## RESPONSE TO REQUEST FOR ADDITIONAL INFORMATION

### APR1400 Design Certification

Docket No. 52-046

RAI No.: 434-8352  
SRP Section: SRP 19  
Application Section: 19.1  
Date of RAI Issue: 03/08/2016

Figure 19.1-48A At-Power Seismic Event Tree

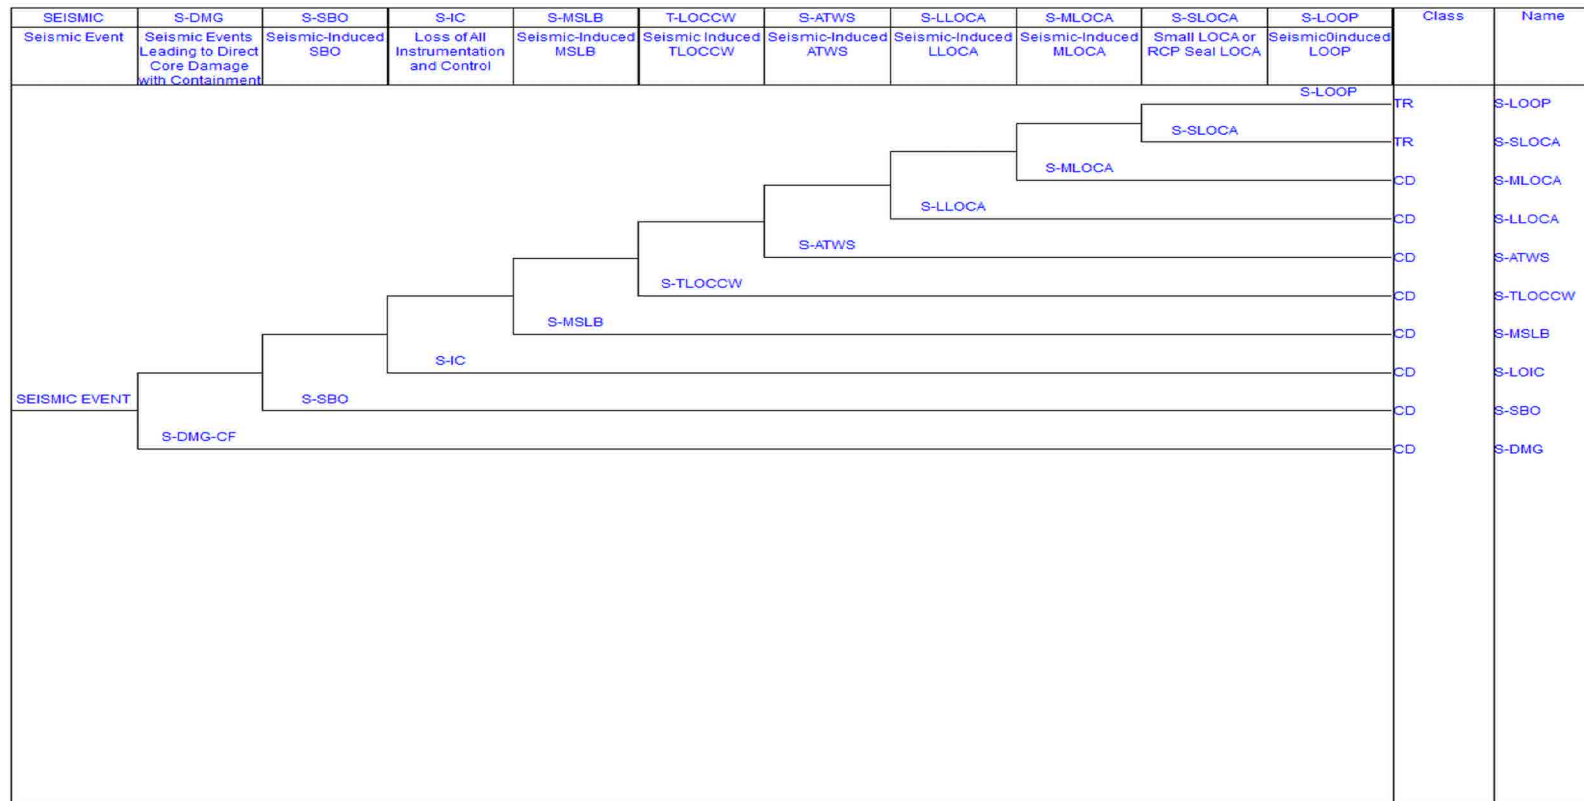
In APR1400 DCD, Section 19.1.5.1.1 "Description of the Seismic Risk Evaluation," the applicant describes the methodology (Tasks (a) through (g)) used to evaluate the seismic margin. However, the staff review finds that, among these tasks, only Task (b) "Development of seismic equipment list" and Task (e) "Fragility analysis" are discussed in detail in Sections 19.1.5.1.1.1 and 19.1.5.1.1.2, respectively. Therefore, in order for the staff to reach a reasonable assurance finding, please address by providing and discussing in detail the analyses performed for Tasks (a), (c), (d), (f), and (g) in the APR1400 DCD, including the following items:

- a) Consequential initiating events that were actually quantified in the seismic model
- b) Recoveries of mitigating systems and seismic related failures that were credited in the PRA-based seismic margin analysis (SMA)
- c) The modeling of structures, systems, and components (SSCs) that are not on the seismic equipment list (SEL) in SMA analysis, if any

System logic models, i.e., fault trees, that were developed for the internal events PRA model were used as the basis for the PRA-based SMA logic models. The PRA-based SMA logic models include the seismic failures. Details of the fault tree logic model development for systems where explicit evaluation of seismic failures needed to be included are provided in the subsections that follow. The developed model was for seismic induced initiating events which were identified and shown in the seismic induced initiating event tree illustrated in figure 19.1-48A.
